## Department of Transportation

#### MEMORANDUM

**SUBJECT:** ZC Case No. 22-11 – 807 Maine Avenue SW

**Figure 1 | Site Plan**

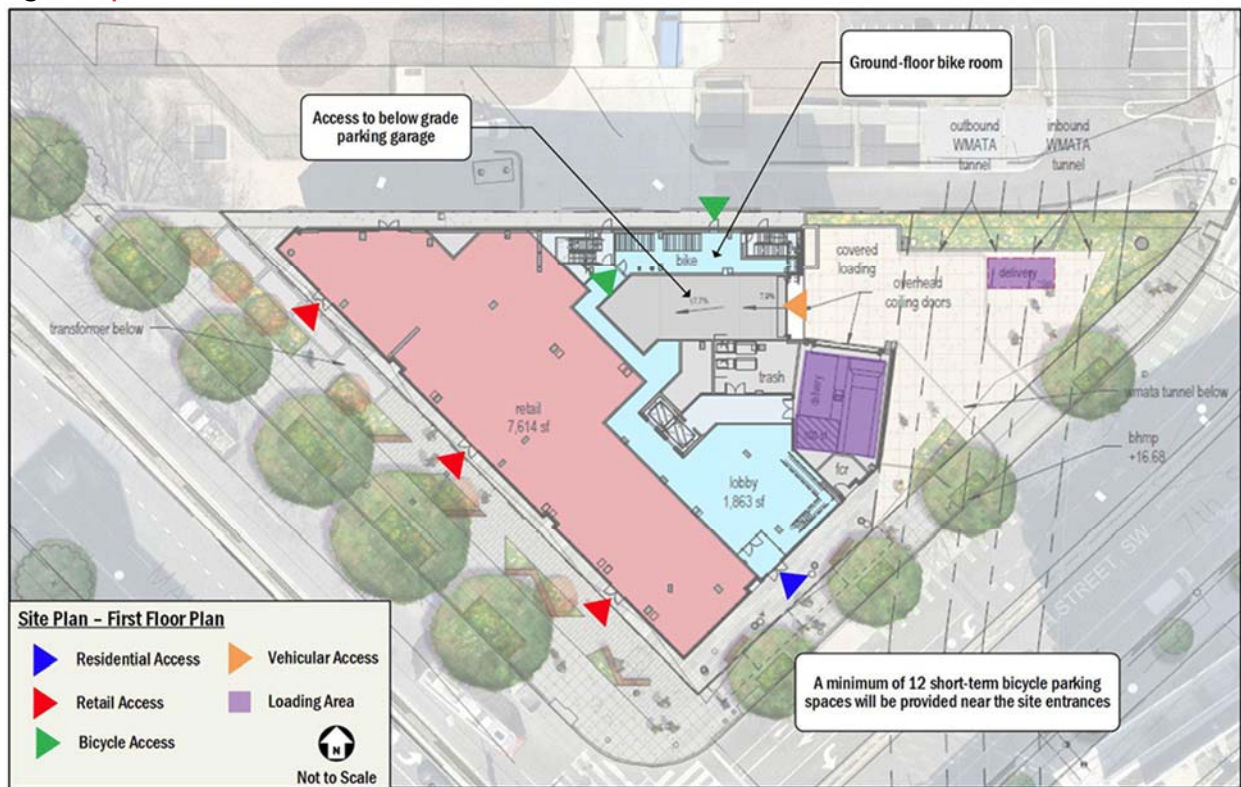
While the preliminary public space plans, shown above in Figure 1, are generally consistent with DDOT standards, there are several considerations that need to be reviewed in greater detail during the public space permitting process:

- The District Government-owned parcel fronting Maine Avenue SW should be treated as if it were DDOT public space and be as green and 'park-like' as possible. The Applicant should continue to coordinate with DDOT and DMPED on the Transfer of Jurisdiction;

- Ensure the required protected bicycle lane on 7<sup>th</sup> Street SW meets DDOT's bicycle lane standards and is designed to accommodate the existing bus stop;

- Close the existing curb cut and driveway to 7<sup>th</sup> Street SW and restore the former driveway to green space. The proposed curb cut design and intersection spacing must meet DEM design requirements;

- Minimize the amount of pavement and maximize green space in public space along Maine Avenue SW;
- Any vaults should be out of the sidewalk area and screened from view;

- Determine final locations for the inverted-U bicycle racks.
